## 9-Spline 5mm Wide Sprocket Base

Gates Carbon Drive announces a change to our 9-Spline rear sprocket line. All new 9-Spline rear sprockets will come with a wider 5mm mounting base. This change in width allows for a stronger sprocket, but also spreads the load through a larger bearing surface, which is better when used in combination with aluminum freehub bodies.

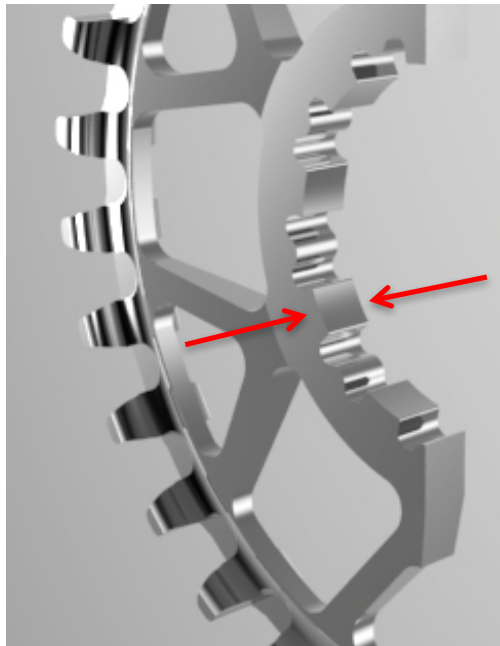
The extra width is added to the outboard side of the sprocket so that the spacer stack from the freehub to the sprocket does not need to be changed. Spacers outboard of the sprocket will have to be adjusted.
